# **TRANSPORT OF DANGEROUS GOODS**

## **Manual of Tests and Criteria**

*Amendment 1*

ST/SG/AC.10/11/Rev.4/Amend.1
------------------------------

**Figure 41.1: Minimum SRS Curve**

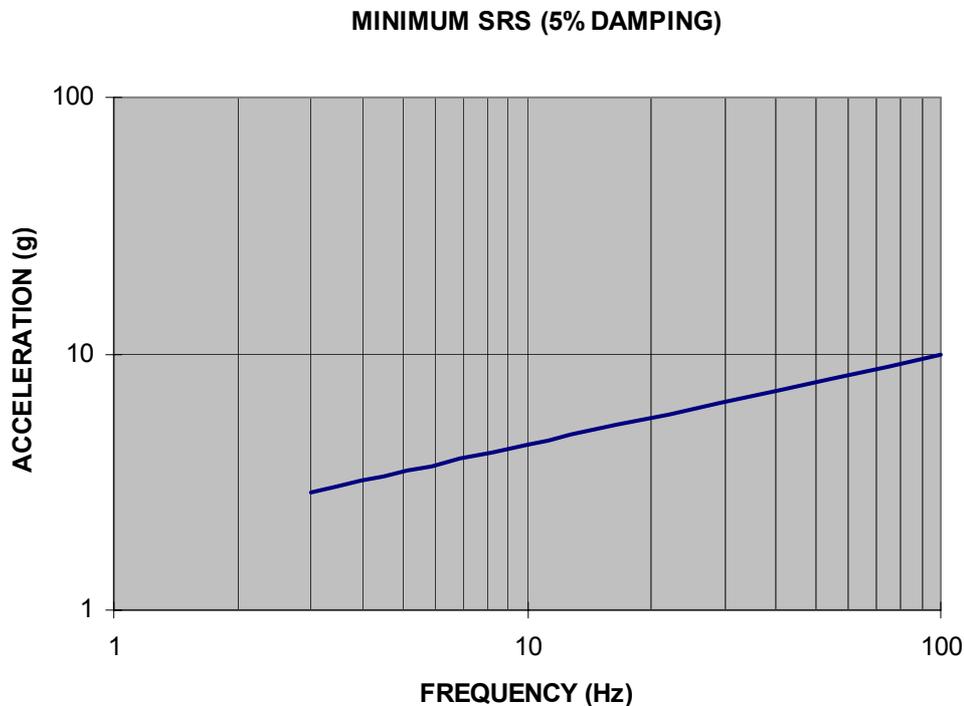
41.3.4.4 An impact shall be created (see 41.3.2) such that for a single impact the as tested Shock Response Spectrum (SRS, see 41.3.5.1) curve at both corner fittings at the impacting end equals or exceeds the minimum SRS curve shown in Figure 1 at all frequencies within the range from 3 Hz to 100 Hz. Repeated impacts may be required to achieve this result but the test results for each impact shall be considered individually;

Equation for generating the above Minimum SRS Curve:  $ACCEL = 1.95 \text{ } FREQ^{0.355}$

FREQUENCY (Hz)	ACCELERATION (g)
3	2.88
10	4.42
100	10.0

**Figure A5.1: 10 LITRE VESSELS FOR VENTING TESTS".**

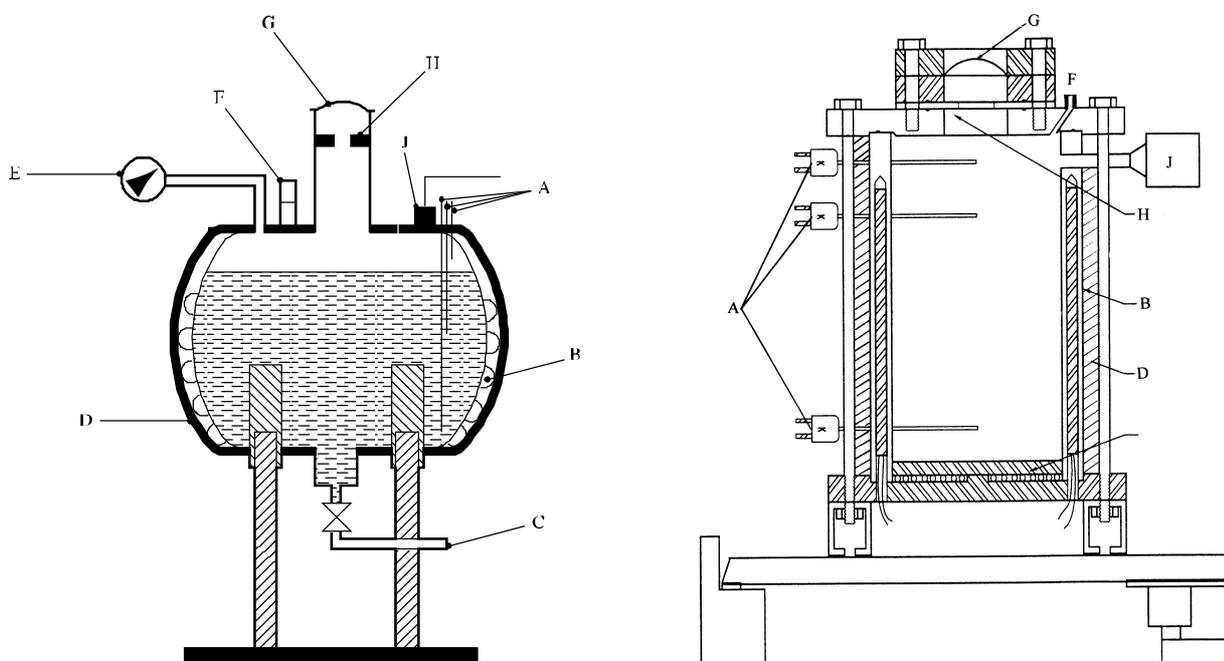
Amend to read as follows:

The reduced scale tank consists of a stainless steel test vessel with a gross volume of 10 l. The top of the tank is provided with either a 1 mm opening which simulates the pressure relief valve (PRV) of the IBC or tank or a real PRV of a diameter which is scaled using the vent area to vessel volume ratio. A second opening simulates the emergency vent opening and is closed by a bursting disk. The diameter of this vent opening can be varied by using orifice plates with different apertures. The bursting pressure of the disk fixed to the 10 l vessel should be equal to the maximum rupture pressure of the bursting disks to be fitted to the IBC or tank. This pressure should be lower than the test pressure of the tank involved. Usually, the bursting pressure is set at a level that can cope with the pressures encountered during normal transport conditions such as hydrostatic pressure from the liquid due to turn over of the tank, slopping of the contents, etc. The 10 l vessel should be provided with a bursting disk with a set pressure in the range of the disk(s) fitted on the tank or IBC as to be used in transport. For safety, it is recommended to provide the test vessel with an extra bursting disk (bursting pressure approximately 80% of the design pressure of the 10 l test vessel) with a large opening for additional emergency venting of the test vessel in the event that the chosen orifice diameter is too small.

- 
- (A) Thermocouples (two in liquid on one in vapour space)
  - (B) Heating coil/heating cartridge
  - (C) Drain line, optional
  - (D) Insulation
  - (E) Manometer, optional
  - (F) Pressure relief valve, optional
  - (G) Bursting disk
  - (H) Orifice plate
  - (J) Pressure transducer or pressure relief valve & transducer on tee
-
